**Order by the Building Authority under section 24(1)**

Order No	: C/TF/000506/16/K	Office of the Building Authority
BD Ref.	: EB/4006/95/T04S	12/F - 18/F., Pioneer Centre,
To	: The Owner of	750 Nathan Road, Mongkok,
	7TH FLOOR OF 38 PLAZA NO.38 SHANTUNG STREET	Kowloon.
	KOWLOON

7TH FLOOR OF 38 PLAZA NO.38 SHANTUNG STREET KOWLOON

**7<sup>TH</sup> FLOOR PLAN**

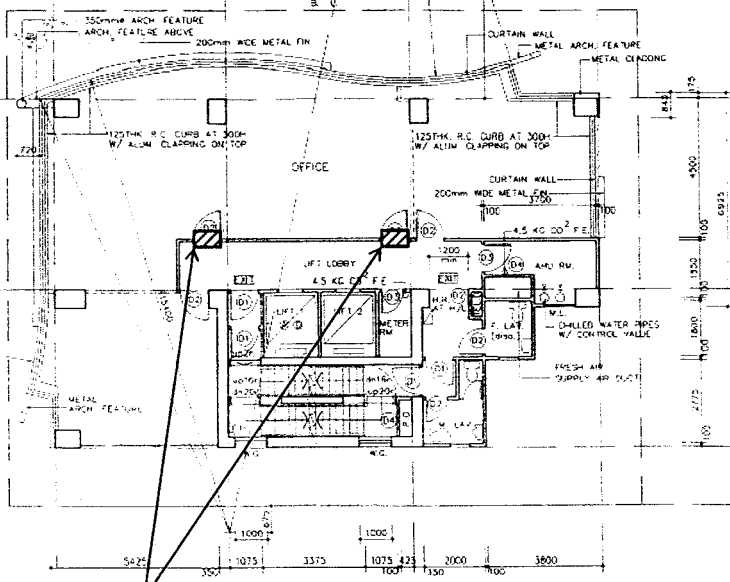
- (i) A fire-resisting door at the entrance of the premises removed and replaced by a door of inadequate fire rating.  
(The location of the building works described above is shown hatched-black on the plan annexed hereto, for the purpose of identification only)

- (a) As a result of the building works at items (i) above, Regulation 90 of the Building (Construction) Regulations, which requires the building to be designed and constructed so as to inhibit or provide adequate resistance to the spread of fire and smoke; and to maintain stability of the building in case of fire, has been contravened.

- (a) reinstate the parts of the building so affected by the building works under item (i) above in accordance with the \*plans approved by the Building Authority / ~~minor works completion record submitted to the Building Authority.~~
